EPC STORMWATER REVIEW COMMENTS
IN ORANGE BOXES WITH BLACK TEXT

MERIDIAN STORAGE

CONSTRUCTION DRAWINGS

CONSTRUCTION DRAWINGS
MERIDIAN STORAGE
MERIDIAN STORAGE, LLC
STATE OF COLORADO
EL PASO COUNTY, FALCON, CO 80931
ADDED FILING NUMBERS
SF-23-XXX
VR239

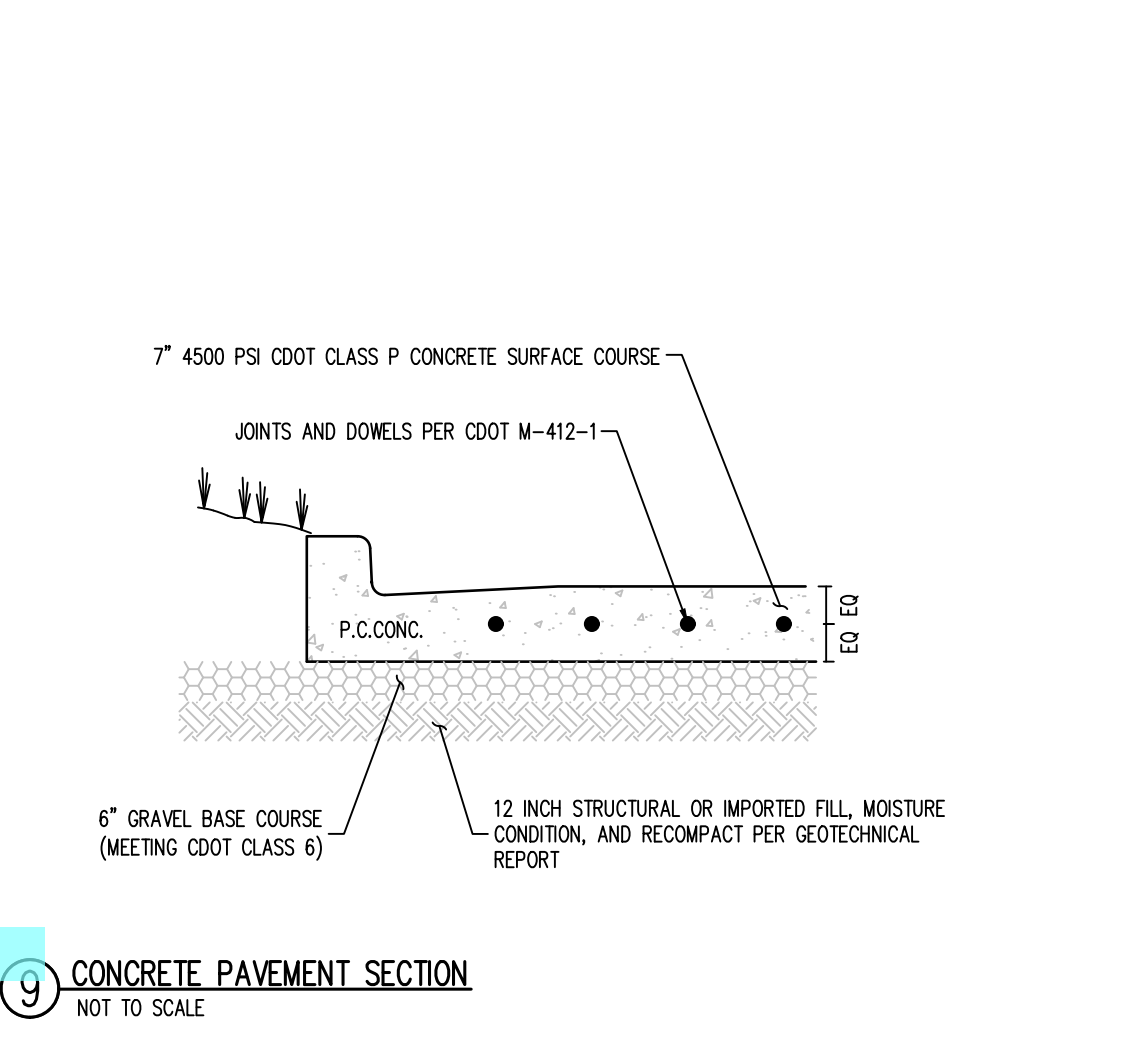
County
REVISED TO COUNTY

revise to 30"x30"
REVISED TO 30"x30"

C3.4

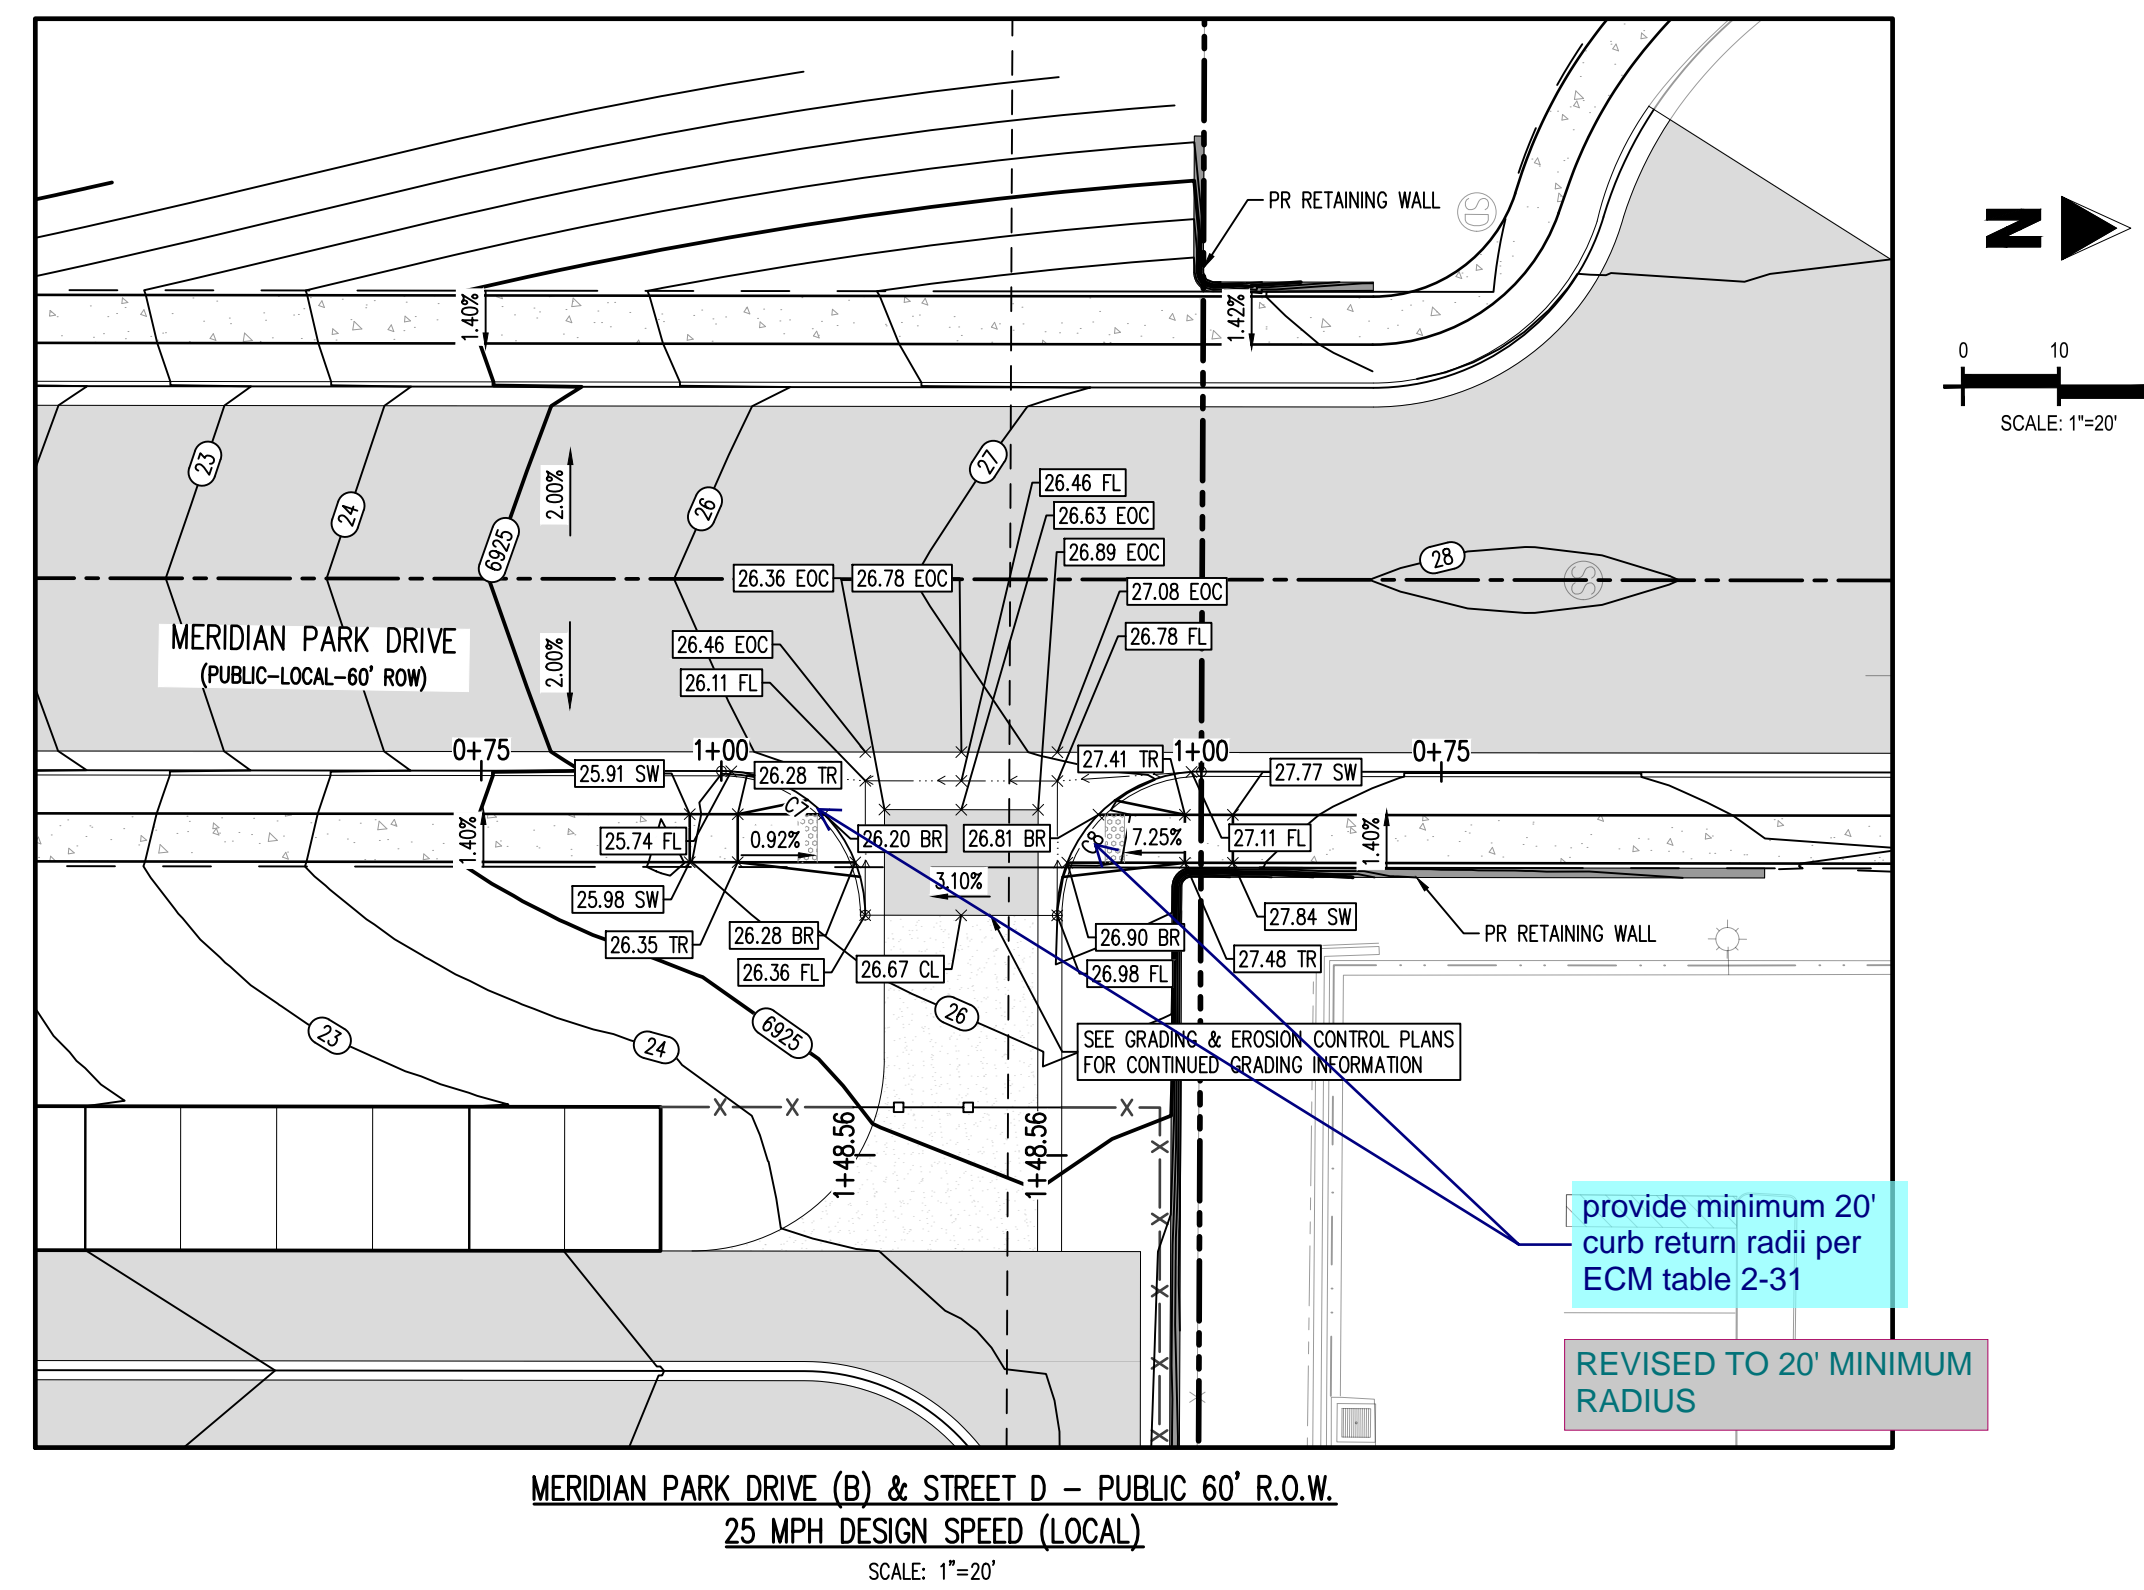
provide minimum 20' curb return radii per ECM table 2-31
REVISED TO 20' MINIMUM RADIUS

STORM DRAIN PLAN - LINE C
 SCALE: 1"=30'

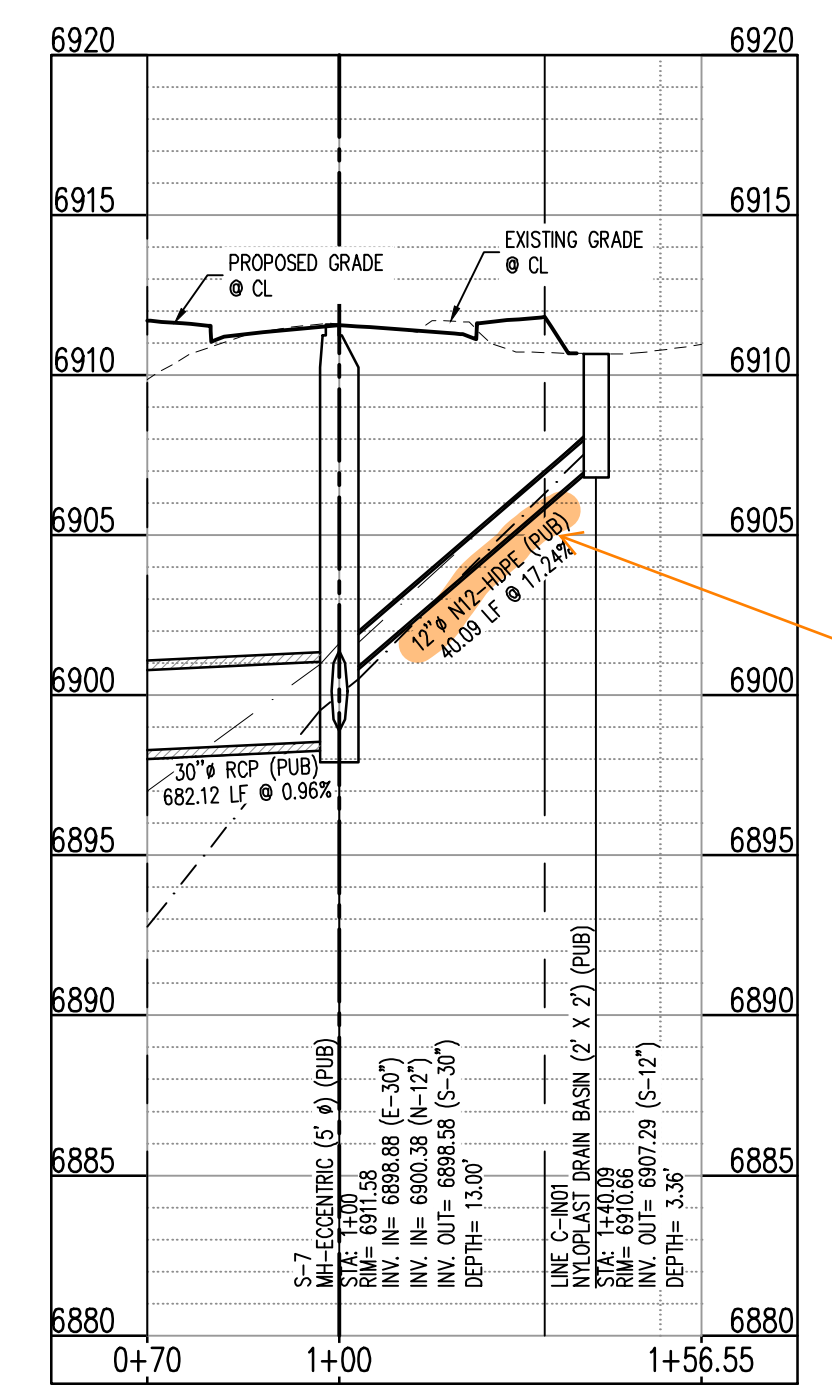
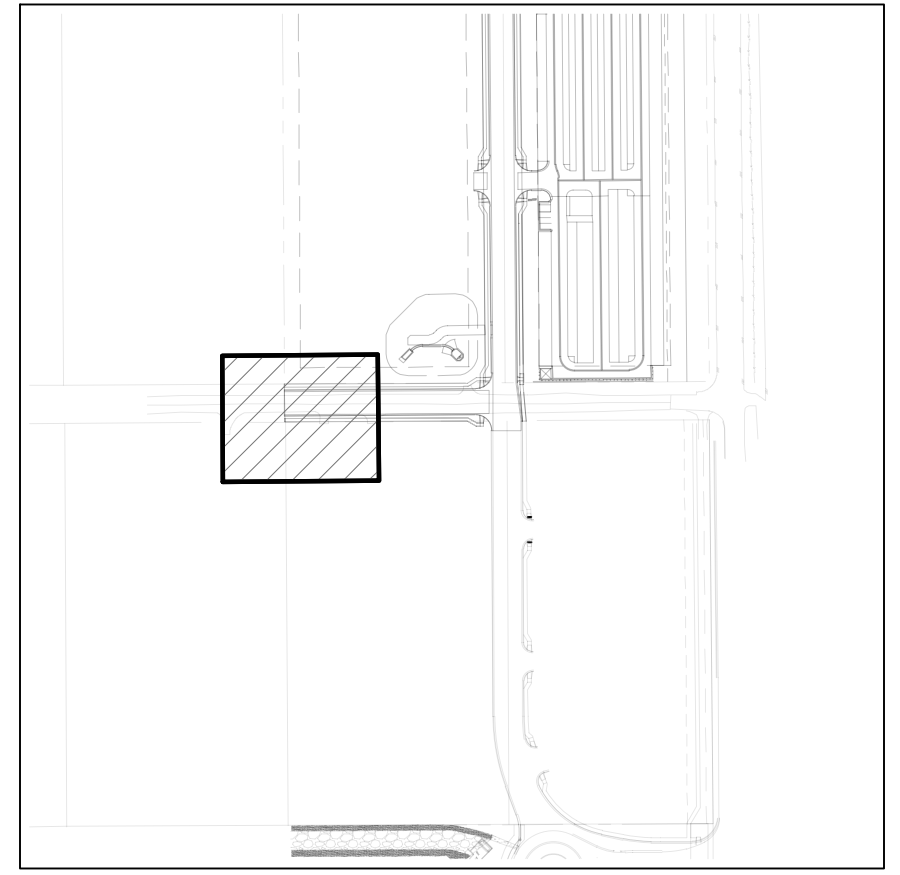
all storm sewers within the County's ROW are required to be RCP and a min. 18". See ECM 3.3.1.J.
 CHANGED TO 18" RCP

Plastic pipe is not allowed in County R/W.
 CHANGED TO 18" RCP

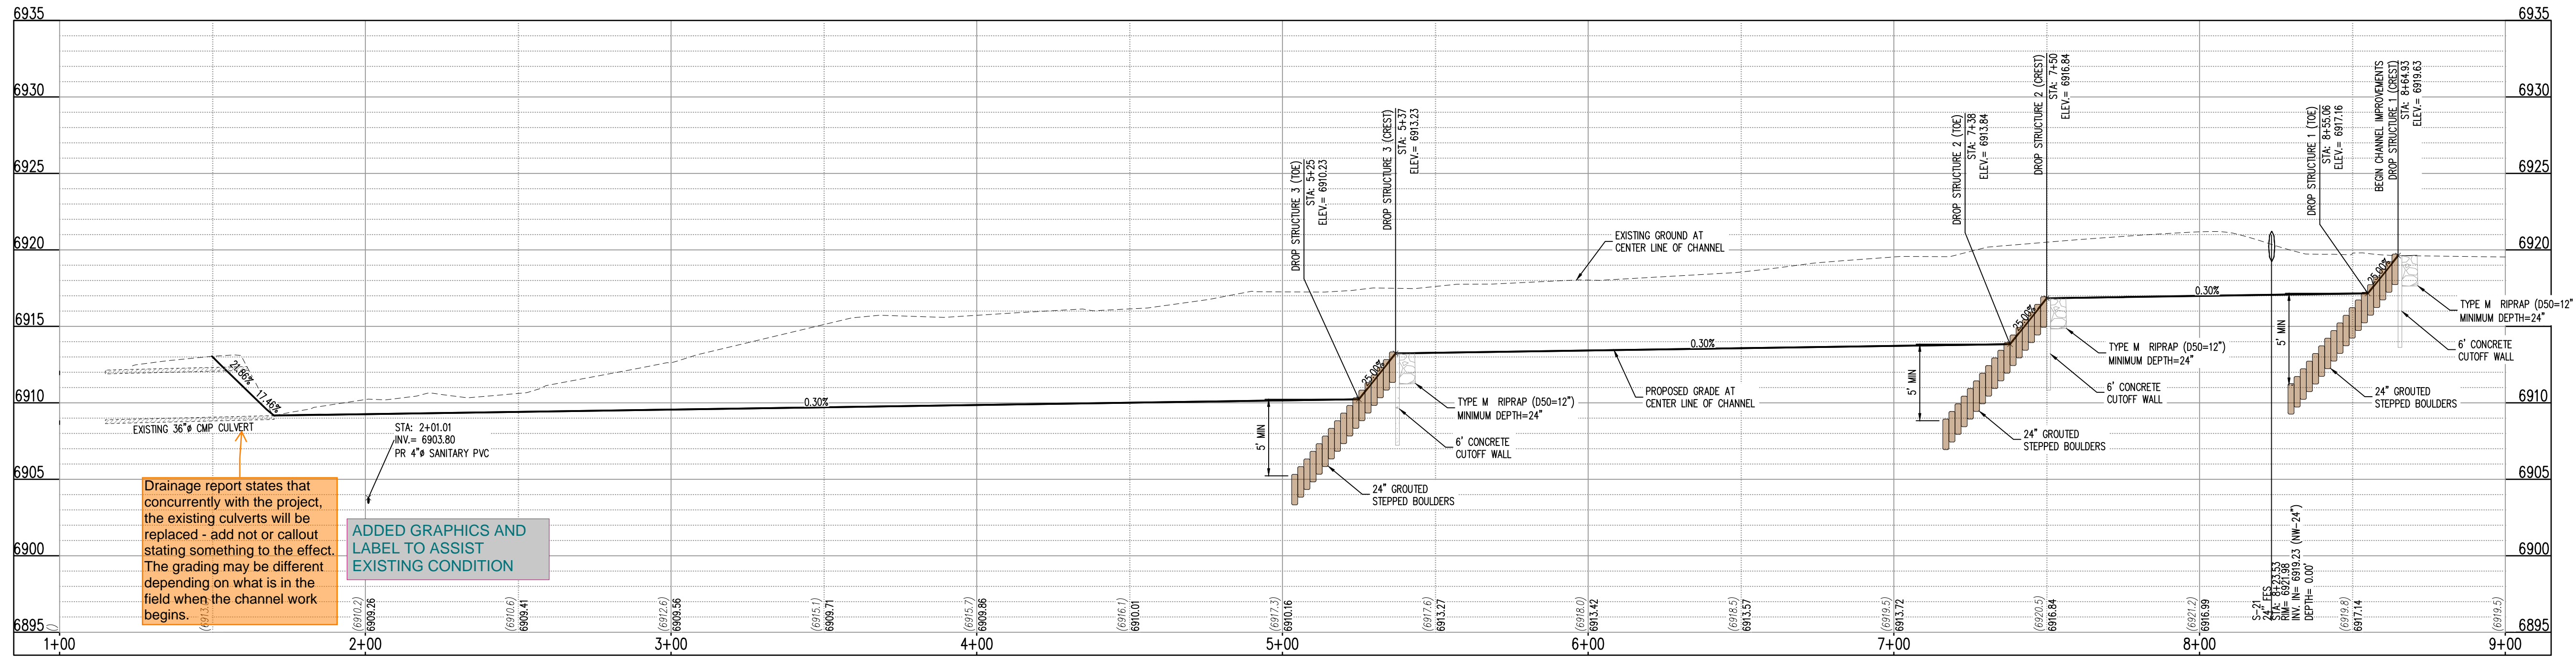
Identify if any additional improvements such as a cut off wall or riprap rundown is needed as the existing outfall will be relocated up the channel slope.

Drainage report states that concurrently with the project, the existing culverts will be replaced - add not or callout stating something to the effect. The grading may be different depending on what is in the field when the channel work begins.

ADDED DETAIL TO SHOW SCOPE OF IMPROVEMENTS
